**918 Panel
Biodiversity Management Plan**

Clarence Colliery

DOCUMENT DETAILS	Name: 918 Panel Biodiversity Management Plan Authors: Tara Boreham / Pippa James / Rebecca Cocks (RPS AAP Consulting Pty Ltd) Number: 918 EP-BMP Revision No.: FINAL Document Status: Submission to DPPI for assessment
-------------------------	--

Figure 6 Terrestrial and Aquatic Monitoring Locations within the 918 EP Area

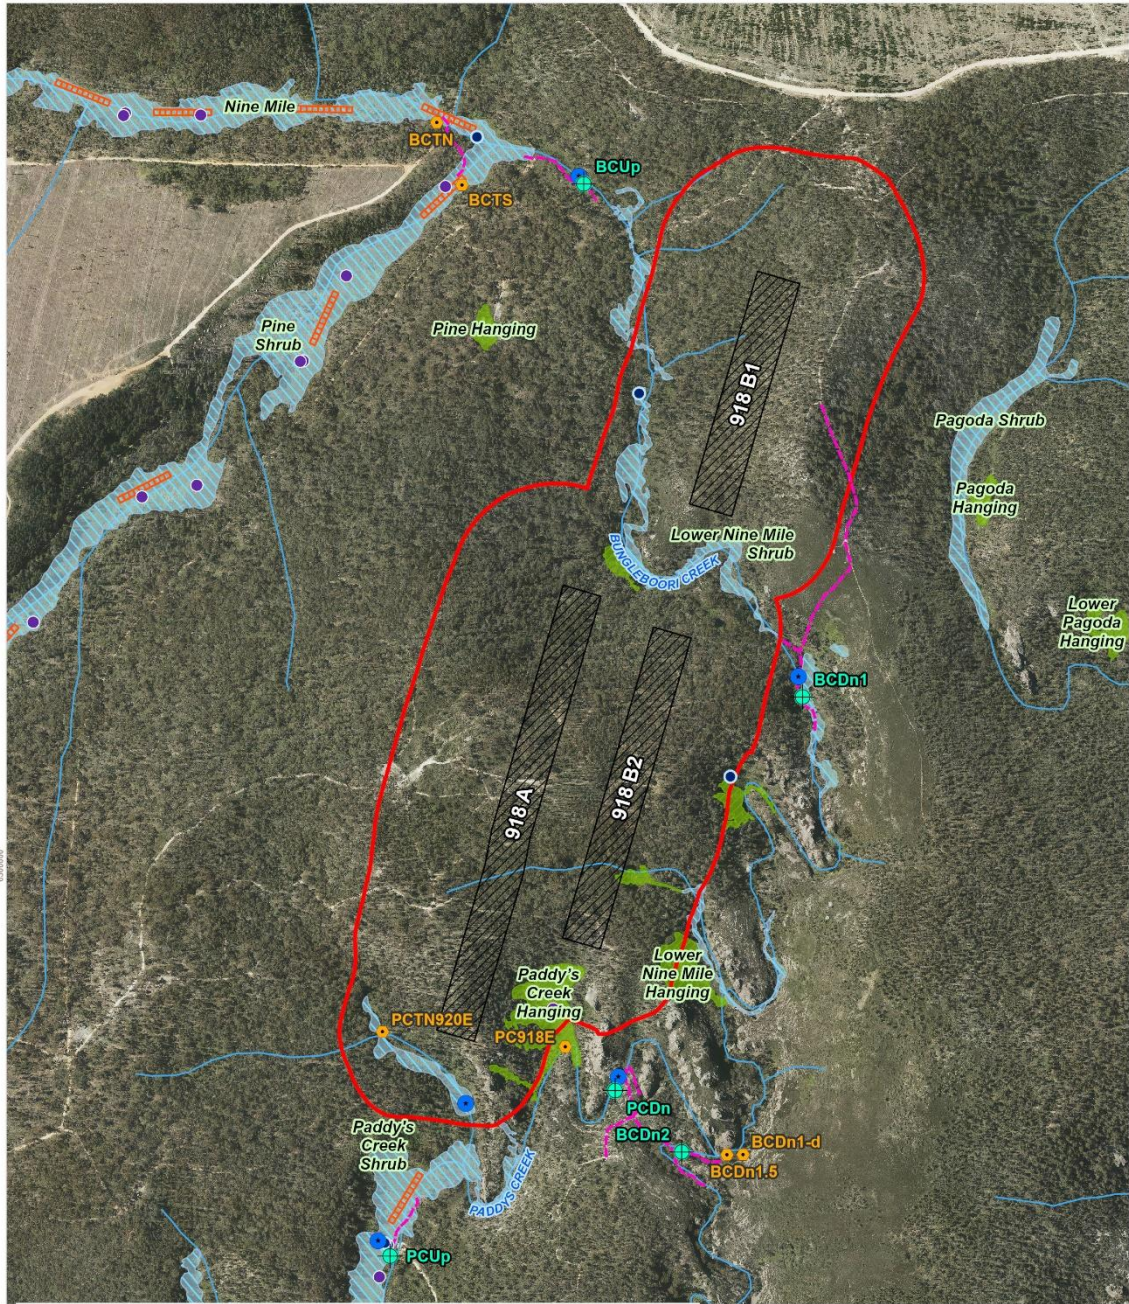
Figure 6 of the Biodiversity Management Plan indicates that there are few proposed biodiversity monitoring sites located in Newnes Plateau shrub and hanging swamps.

Item No.	Matters Raised	Comment and/or where addressed within the BMP
7.1	Apply the monitoring methods listed in Apx Table 16 of the Biodiversity Management Plan as the primary monitoring program for the project, not just if there is a 'condition RED'.	<p>Noted and amended for biodiversity under Management Unit 1 (Table 16, S5.2)</p> <p>Biodiversity monitored under Management Units 2, 3, and 4 have not been moved from Investigative Monitoring (Section 5.3, Table 19) to the routine biodiversity Monitoring Program (Section 5.2, Table 15).</p> <p>Management Units 2 and 3 contain habitats that are considered to be facultative ecosystems. These habitats are by nature, less sensitive to partial extraction mining activities when compared to Management Unit 1 (Swamps). Given the low levels of subsidence predicted, the risk of adverse impacts on these forested communities are considered to be low and therefore only investigate monitoring in the event of a 'condition RED' is considered justified in this instance.</p> <p>In regard to Management Unit 4 (Montane Heath), the mining layout has been designed to avoid undermining the cliff, pagoda and major rock outcrop features in the area, which form part of this Management Unit. In addition to this, the very low-level subsidence effects that are predicted (MSEC, 2026) are not considered to adversely impact these biodiversity features. Steep slopes also form part of Management Unit 4, and again it is considered that these features will not be adversely impacted by undermining (MSEC). Given the predicted very low-level impacts, investigative monitoring in the event of a 'condition RED' is again considered justified for biodiversity associated with Management Unit 4.</p> <p>Ecological Monitoring locations and types of monitoring was reviewed by the Independent Expert Advisory Panel for Mining (IEAPM) in November 2025 and agreed with this approach.</p>

Figure 1 Comparison of approved Subsidence Management Plan boundary from DPIE 2021 (left) to orthorectified boundary held by DCCEEW in purple and boundary provided by Centennial Coal in orange (right).

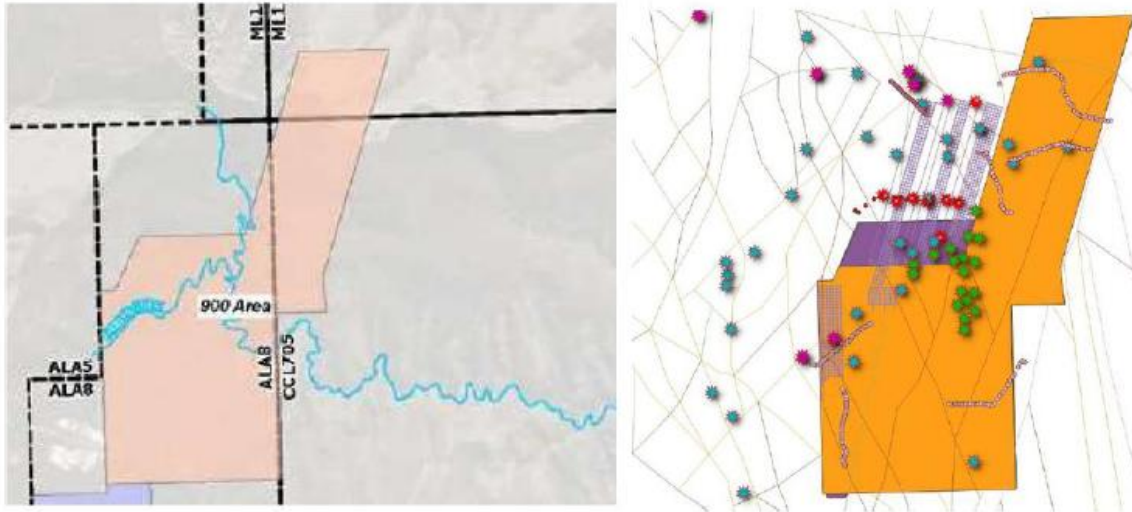
NSW DCCEEW have identified what appear to be a discrepancy between our orthorectified 900 Subsidence Management Plan boundary and the one provided directly by Centennial as part of the EP (Figure 1).

The NSW DCCEEW orthorectified 900 Subsidence Management Plan boundary matches that illustrated by DPIE (2021⁵) whereas Centennial's Subsidence Management Plan boundary does not. Clarification of the Subsidence Management Plan 900 area should be provided, in addition to the provision of the supporting ArcGIS compatible spatial data.
